The CDRC was unable to make the findings for a design review recommendation of approval based on certain design deficiencies. In order to resolve these deficiencies in the project's design, a more thorough review of the "Standards for Design for One-Family and Two-Family Residential Development in the "Midcoast" manual is required. As such, requirements from the CDRC for further project redesign are as follows:

Summary of Changes shown on Page G-550

GROSS AREA PLANS WITH WALLS

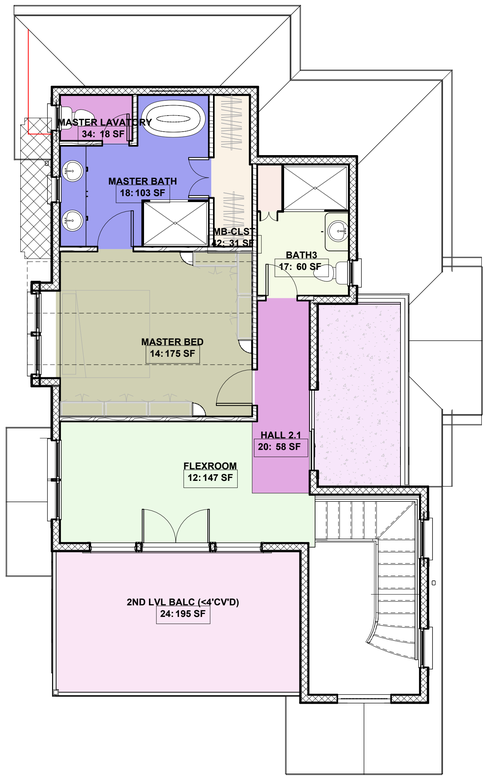
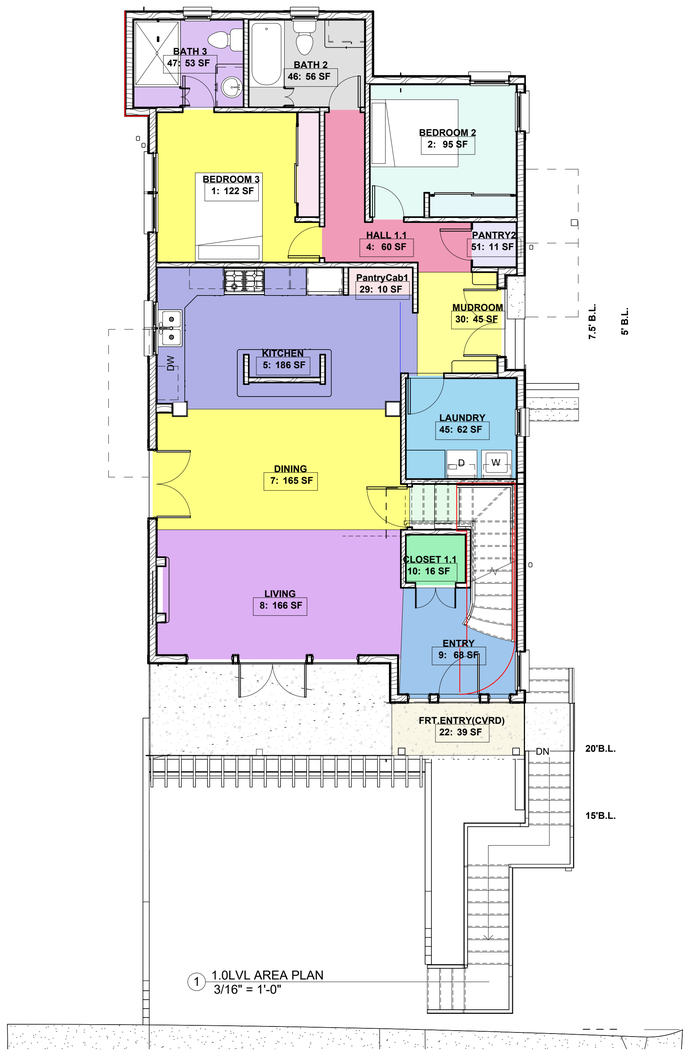
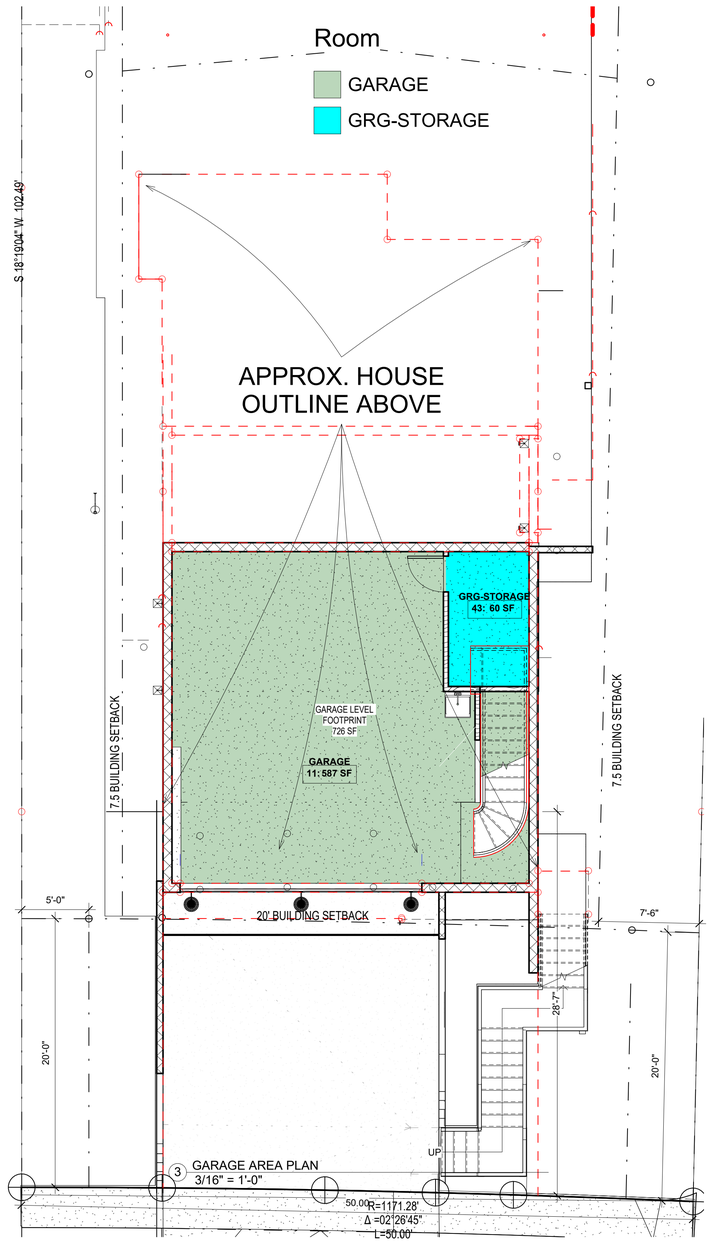
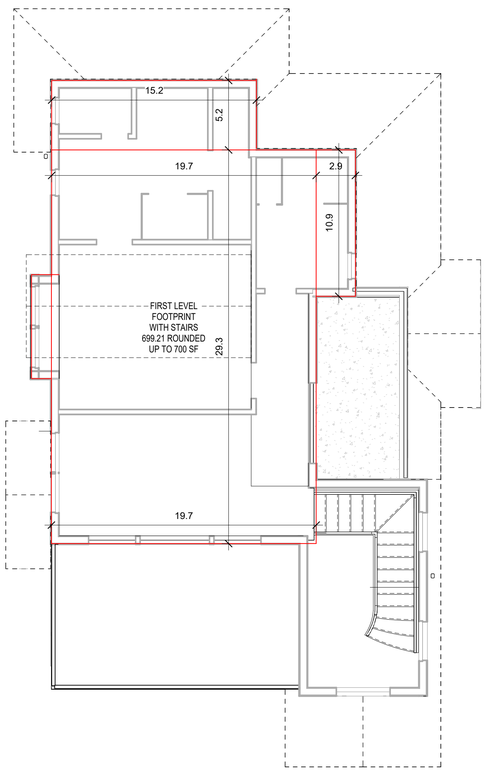
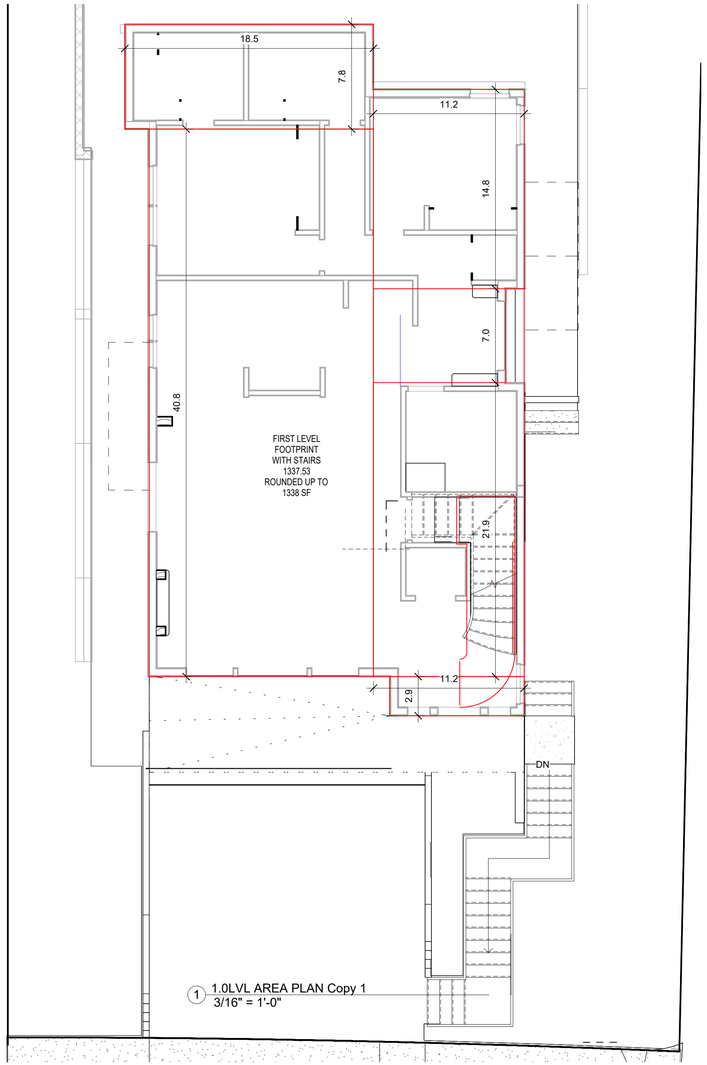
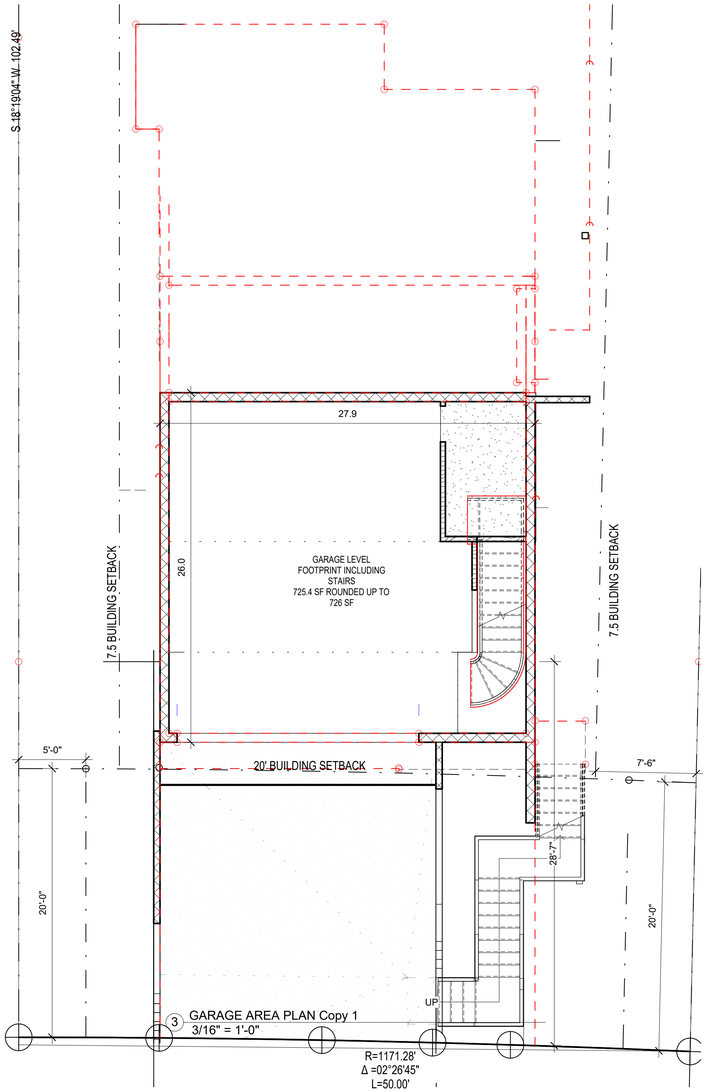
e. Area Plans still are not clearly delineating lot coverage areas and floor areas. The room areas are not relevant to the CDRC review. Provide (2) separate area diagrams to demonstrate lot coverage and floor area, with each area rectangle dimensioned for verification and tabulated in a schedule to show the totals. Be sure to include the garage level and clearly show the extent of the floor area.
